IRPS5401 Errata

Documentation of errata items for the PMIC IRPS5401.

Figure 2 I²C extra pulse error

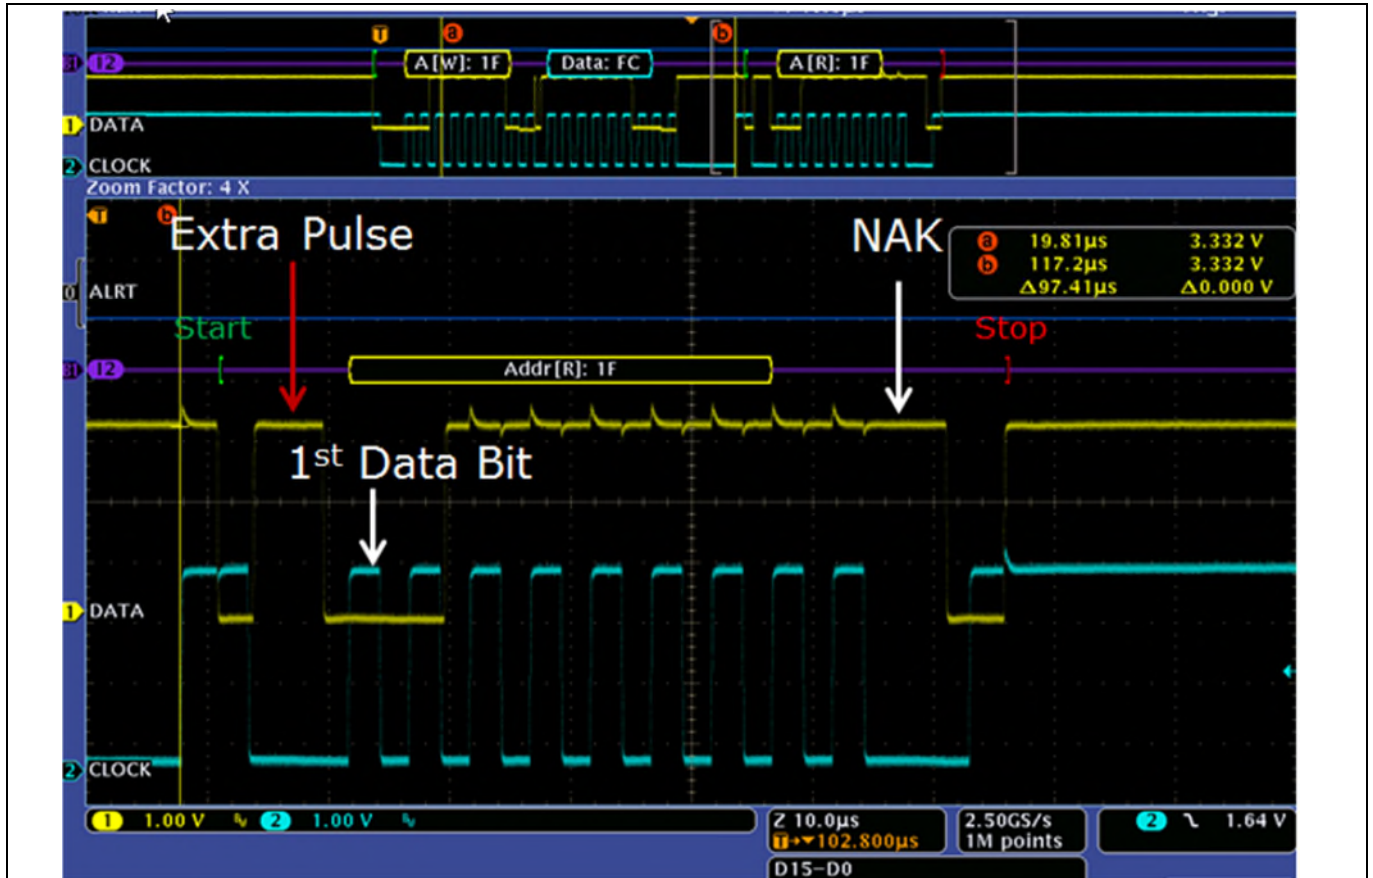
- Erratum:** I²C/PMBus is not tolerant of the DATA changing between the start symbol and the first data bit while the clock is low.
- Issue:** If a low-high-low pulse on DATA occurs between a start (or repeated start) symbol and the first data bit while the clock is low, the device will NAK (Not acknowledge) the transaction.
- Workaround:** The I²C/PMBus master should avoid issuing an extra pulse following the start symbol while the clock is low.
- Corrective action:** None.

Proposed workaround:

The problem with having an extra pulse before the first clock pulse is not that an active pulsing of the data line is happening, rather than the idle state setting for the data line. If the default is low after the start condition was issued, there is no extra pulse. With a high as default and the first address bit (MSB) being “0”, an additional pulse has been created. To prevent this becoming a problem one can select addresses that begin with “1” in the MSB, i.e. 40 h or higher.

The USB005 dongle assumes that the PMBus address is bigger than the I²C address, or else it will not find the PMBus address during scanning.

Therefore, a recommended address setting for third-party interfaces is to set the I²C base address to 40 h and the PMBus base address to 50 h.
